**LAKE MANITOBA AND LAKE
ST. MARTIN OUTLET CHANNELS
PROJECT
Environmental Impact Statement
May 2023 Project Description
Update**

**PROJECT DESCRIPTION
UPDATE**

**LAKE MANITOBA AND LAKE ST. MARTIN OUTLET CHANNELS PROJECT
ENVIRONMENTAL IMPACT STATEMENT
MAY 2023 PROJECT DESCRIPTION UPDATE**

Figure 3C-19a LSMOC Water Control Structure – General Arrangement

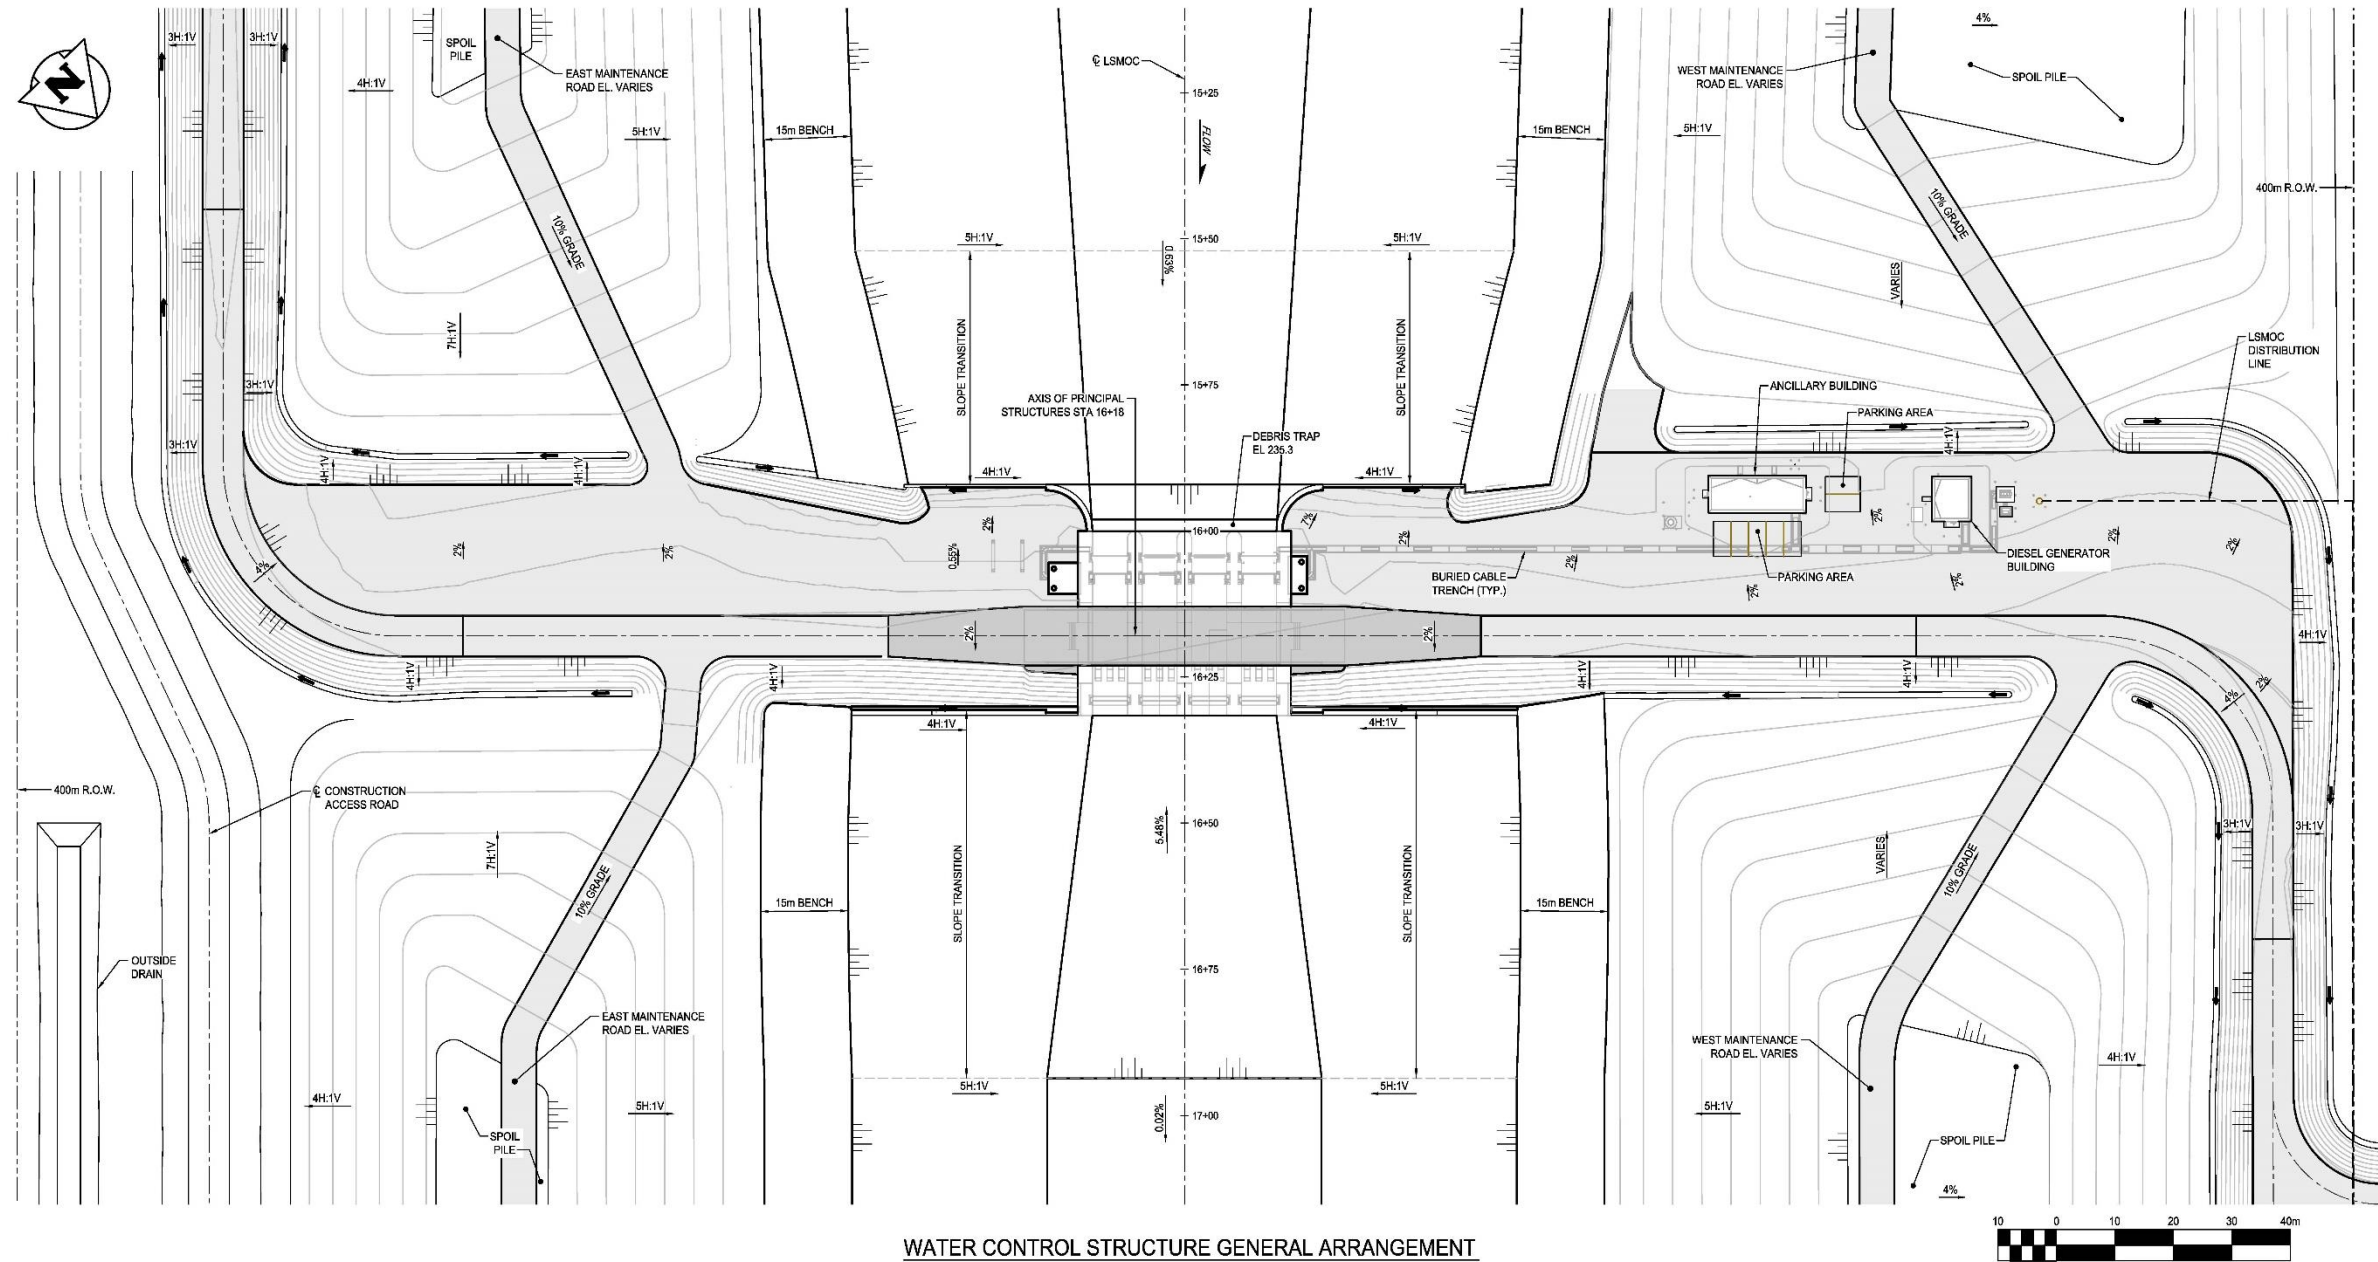
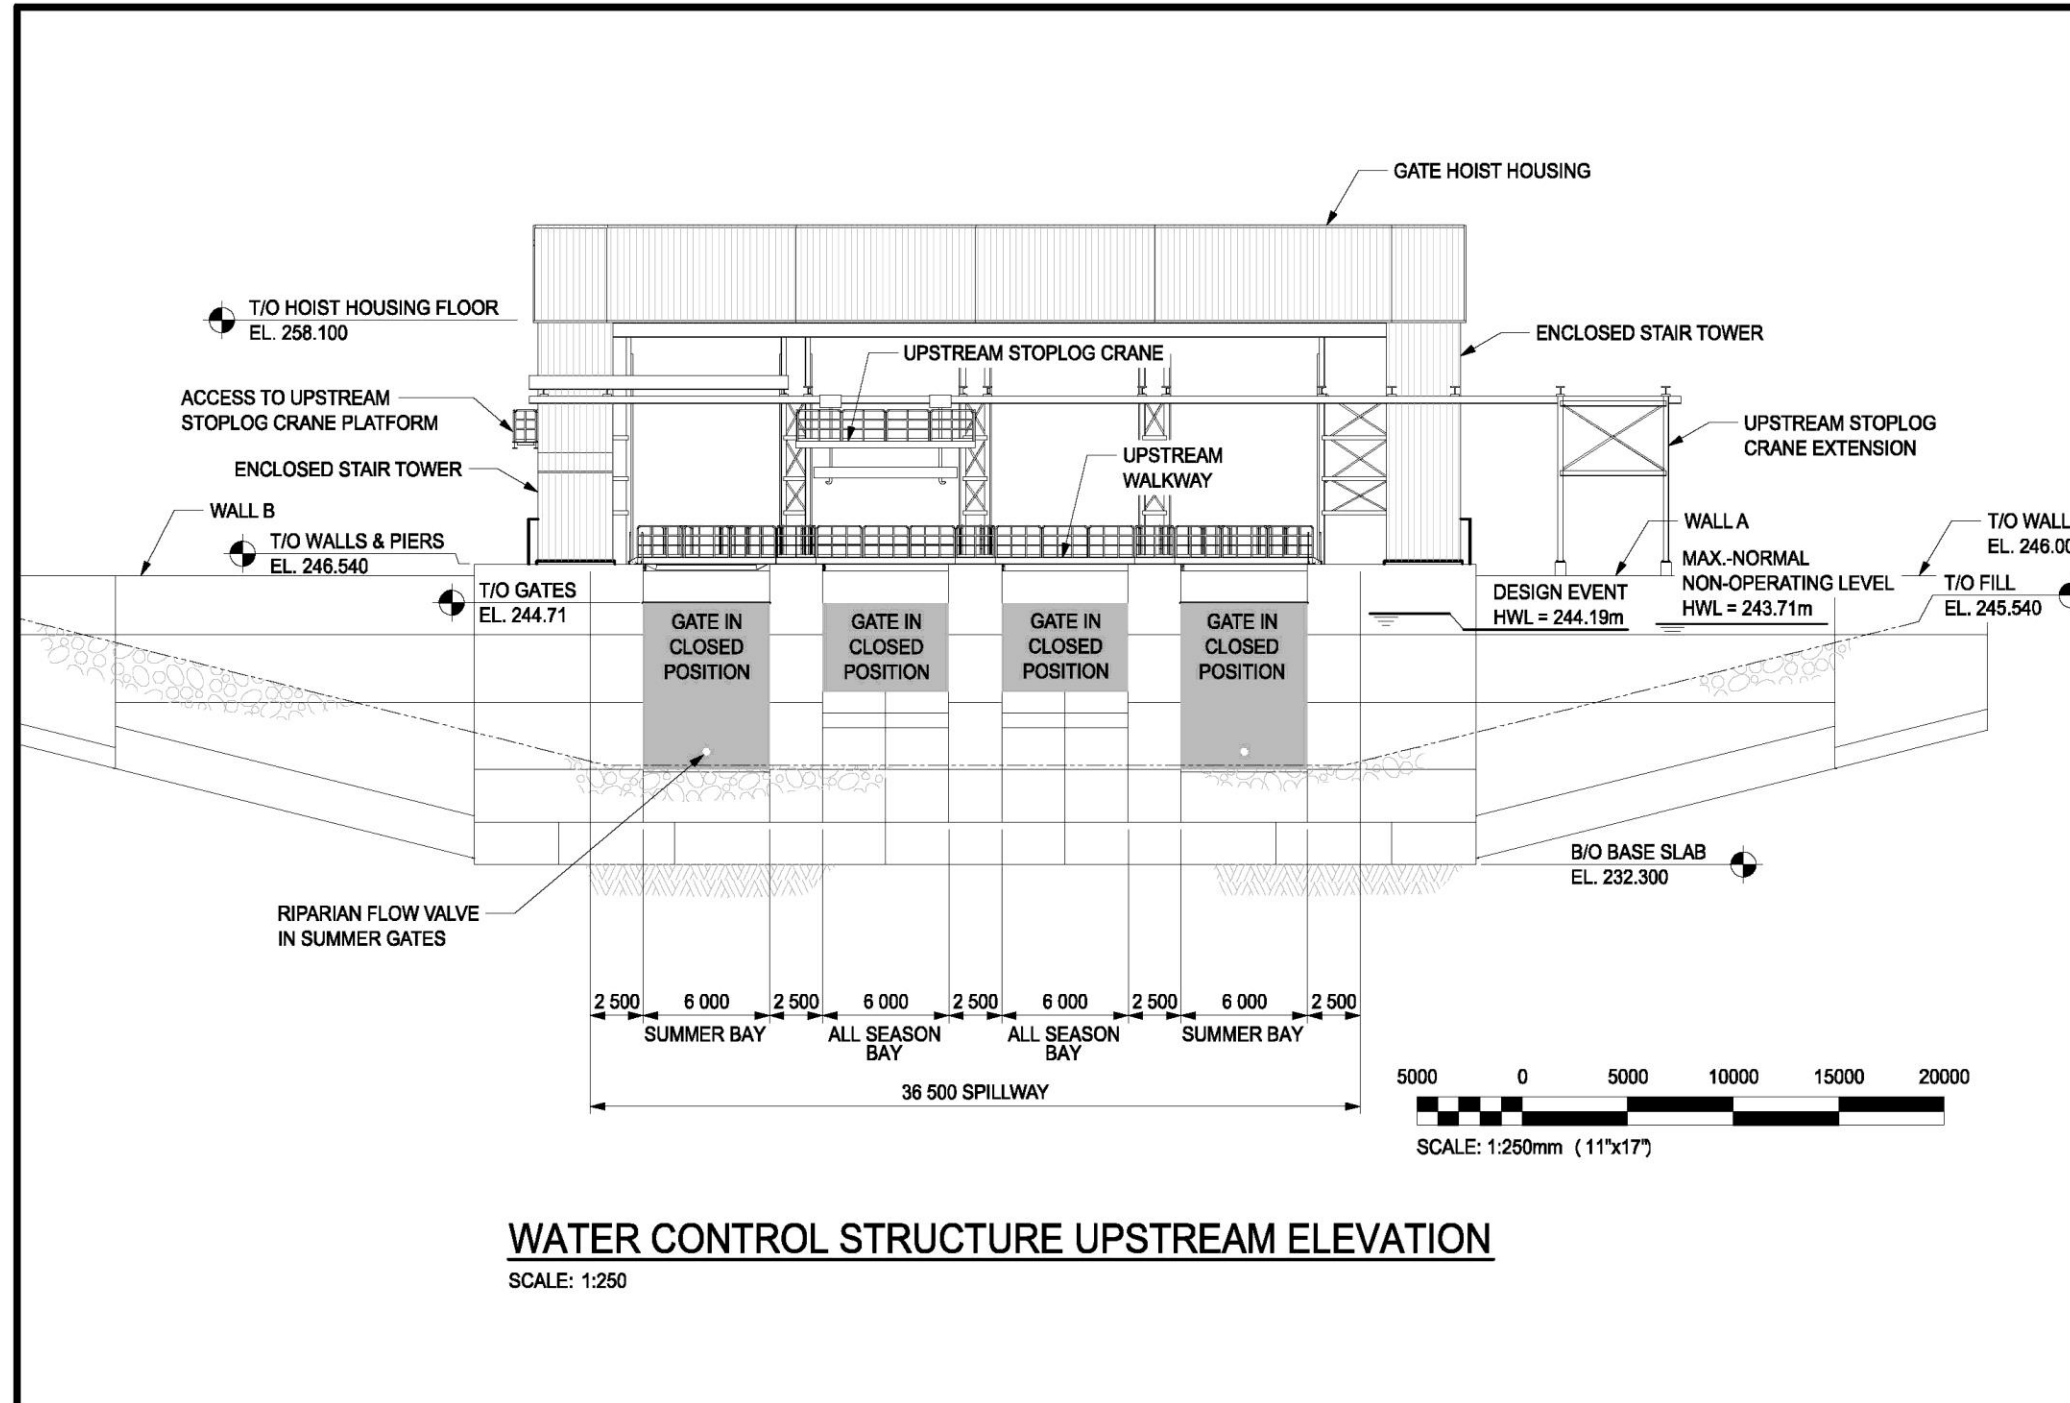
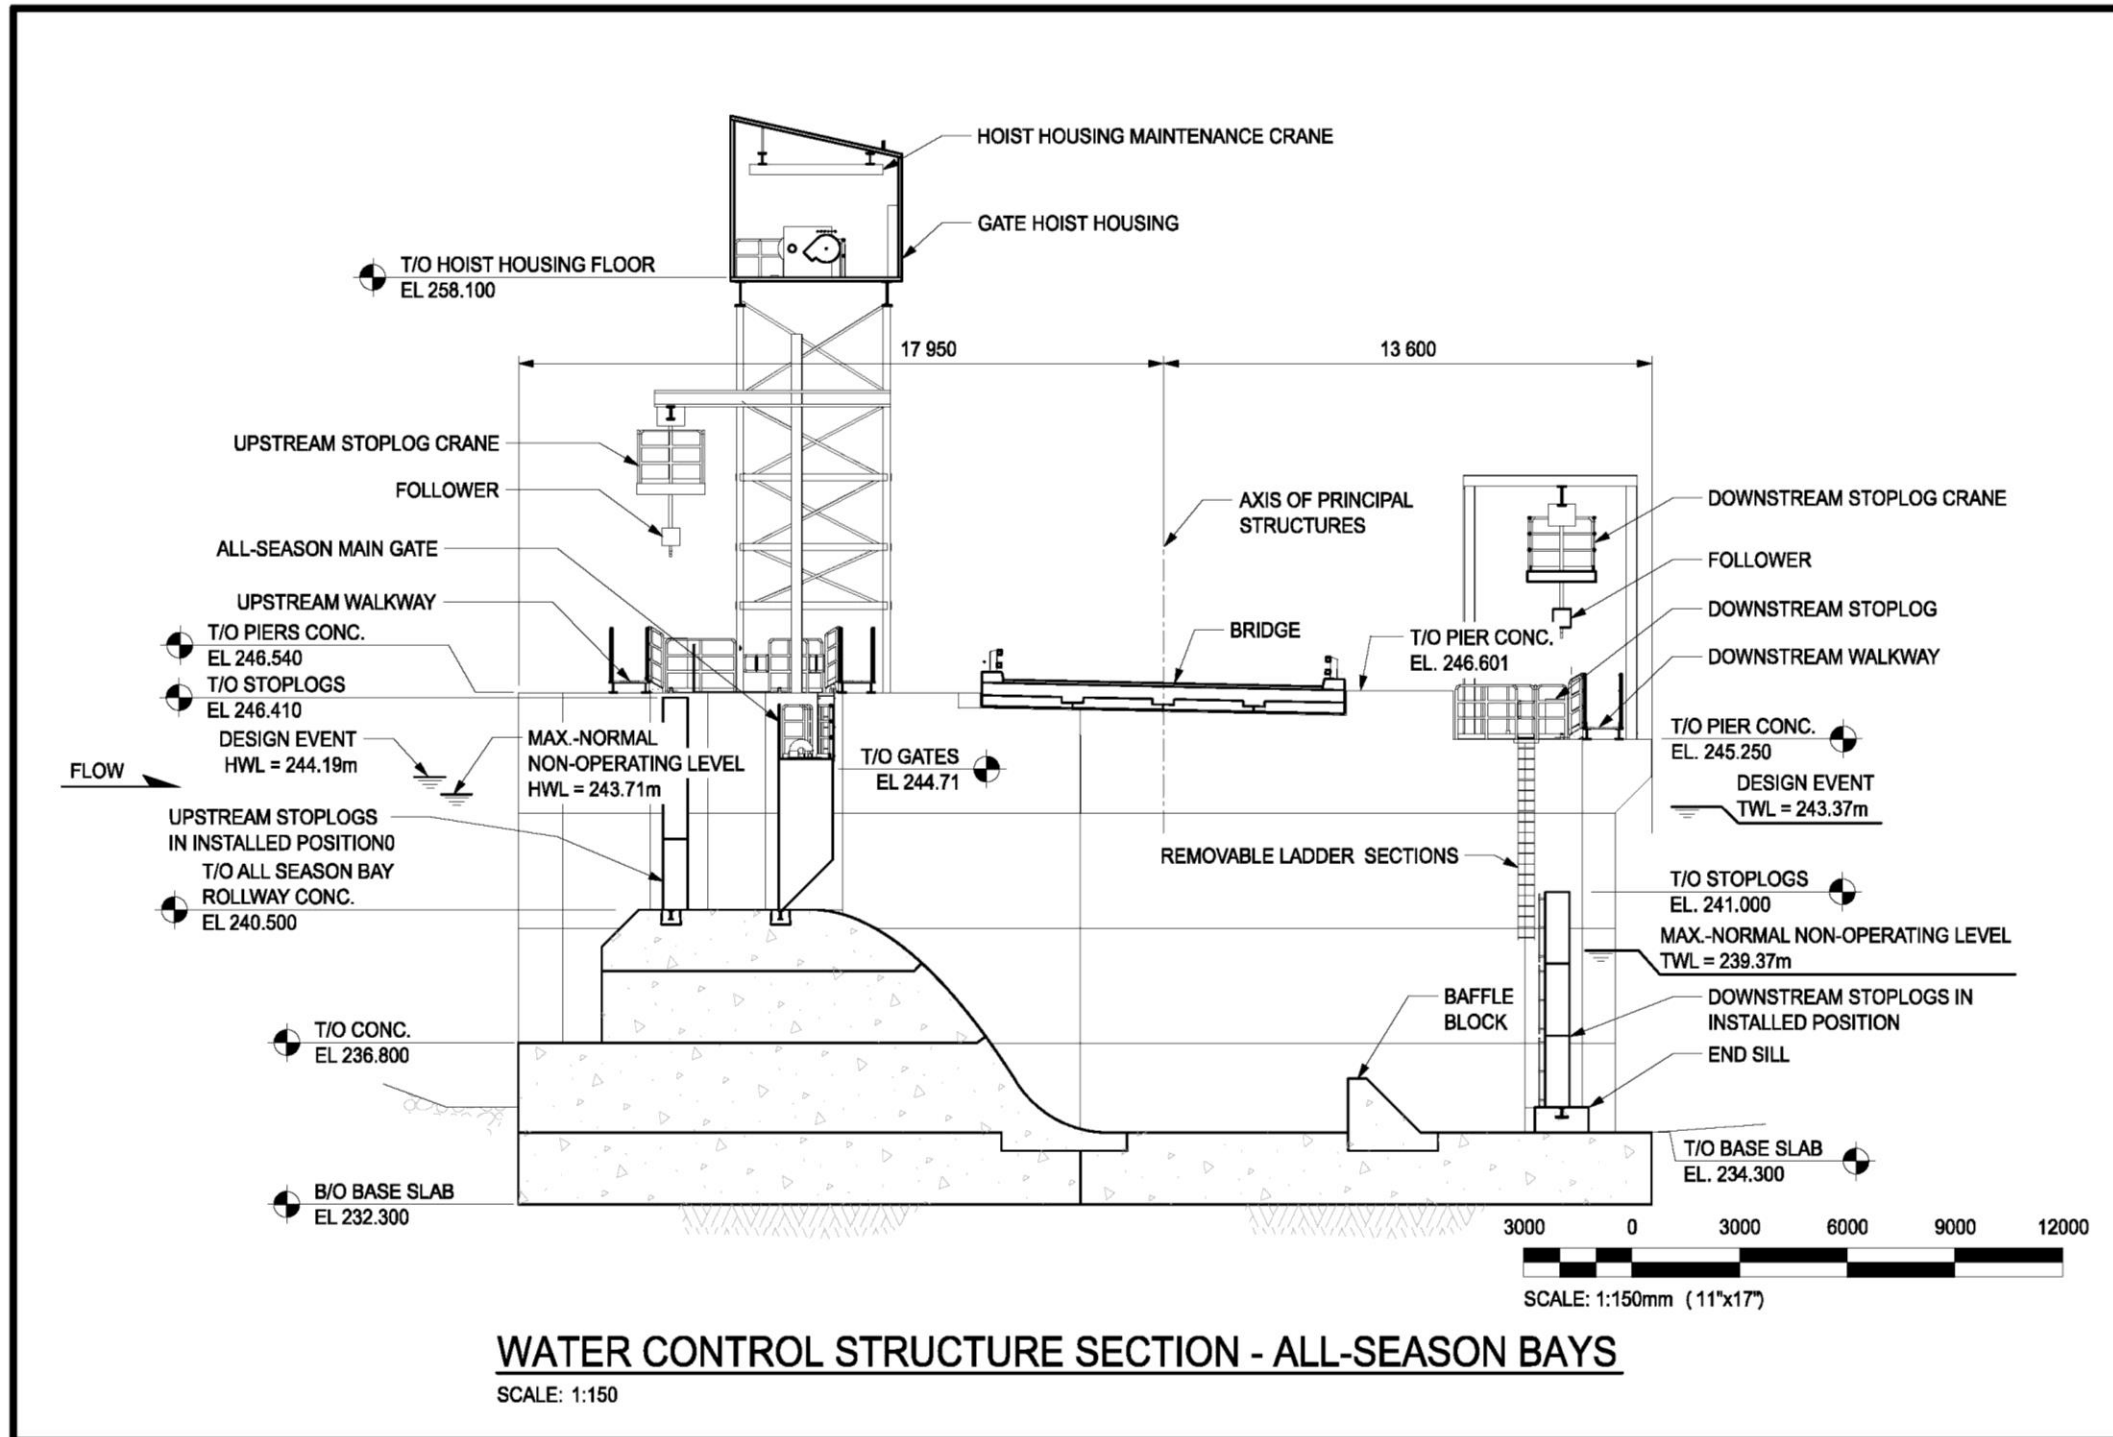
A WCS is required to control flows through the LSMOC while managing Lake St. Martin water levels during flood events. The operations are intended to be consistent with the Operating Guidelines, as filed as part of the June 2022 supplemental information response to IAAC IRs. The current design and changes since the March 2020 Project EIS are shown in Appendix 3C, Figure 3C-19a, 3C-19b, and 3C-19c and described below.

The location of the WCS has not changed from what was presented in the March 2020 Project EIS, but the configuration has been altered. The current design has the WCS located approximately 600 m (1968.5 ft) inland from the shore of Lake St. Martin (see Appendix B, Figure B-3). The WCS will be founded on bedrock. The March 2020 Project EIS indicates that the structure will have two bays, with each being 9 m (20.5 ft) wide. The current design includes a four-bay structure with 6 m (19.7 ft) wide bays. Two bays (outer bays) will have crest elevations of 236.8 m (776.9 ft), and the other two bays (inner bays) will have crest elevations of 240.5 m (789.0 ft). The additional bays will allow greater flexibility in controlling flow into the LSMOC, particularly during winter months. Only the inner bays with higher crests will be operated during the winter (if required). A gated valve will be incorporated into the outer gates to allow a minimum riparian flow (i.e., baseflow) to be provided in the channel, if required, to maintain DO levels in the winter. This is to reduce the likelihood of ice damage to the backside of the gates and allow winter operation at reduced flows. The WCS includes a stilling basin to dissipate flow energy and reduce potential for erosion. The stilling basin design includes rollway profiles, baffle blocks, and a vertical end sill.
